Project	IEEE 802.16 Broadband Wireless Access Working Group < http://ieee802.org/16 >	
Title	Enhancement of 802.16e to Support EAP-based Authentication / Key Distribution Rev. 3	
Date Submitted	2004-01-15	
Source(s)	Jeff Mandin Streetwaves Networking Amatzia 5 Jerusalem, Israel	Voice: 972-50-724-587 Fax: 972-50-724-587 mailto:jeff@streetwaves-networks.com
Re:	Call for contributions to 802.16e security adhoc (11/17/2003)	
Abstract	Description of requirements, mechanism, and security considerations for EAP in 802.16e	
Purpose	Update IEEE C802.16-71/r2	
Notice	This document has been prepared to assist IEEE 802.16. It is offered as a basis for discussion and is not binding on the contributing individual(s) or organization(s). The material in this document is subject to change in form and content after further study. The contributor(s) reserve(s) the right to add, amend or withdraw material contained herein.

Enhancement of 802.16e to Support EAP-based Authentication / Key Distribution

Figure xx

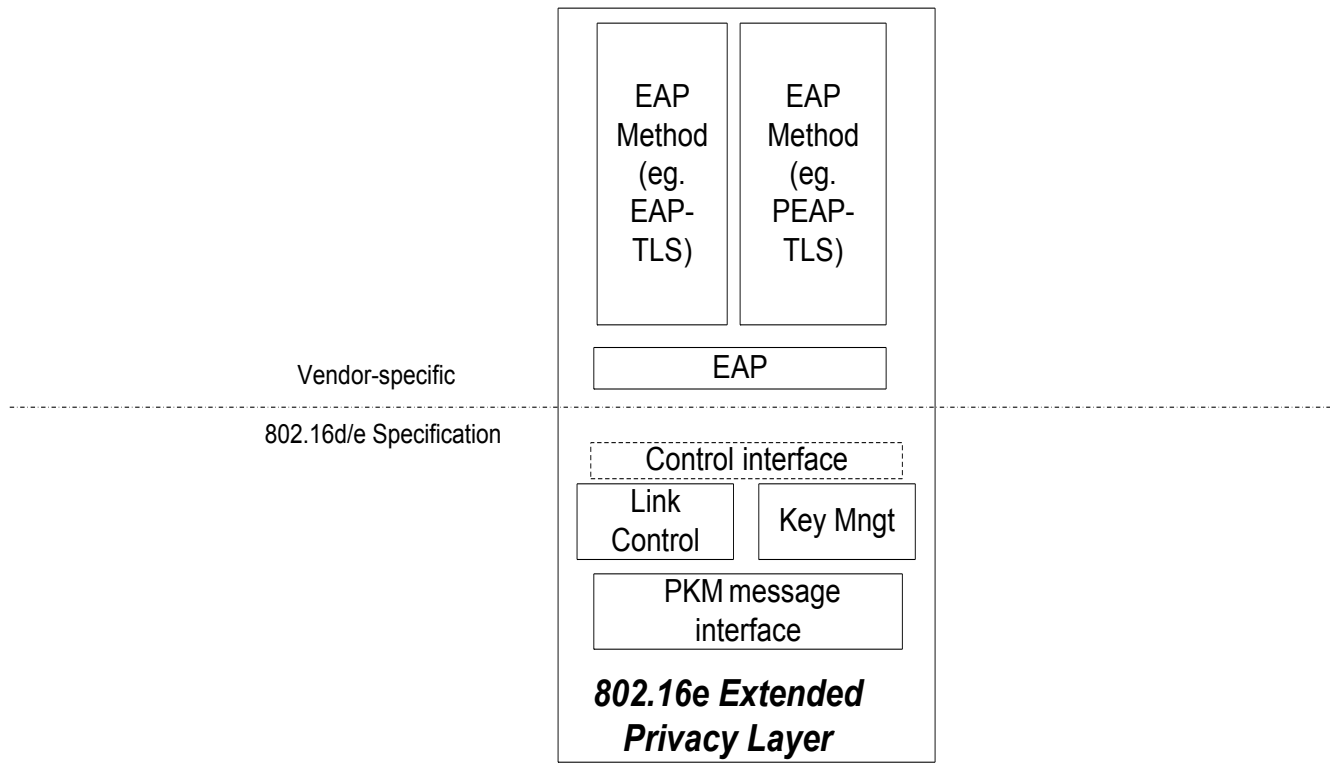
Figure xx shows the relationship between the lower levels of the 802.16 MAC and the generic EAP components (and the interface between them).
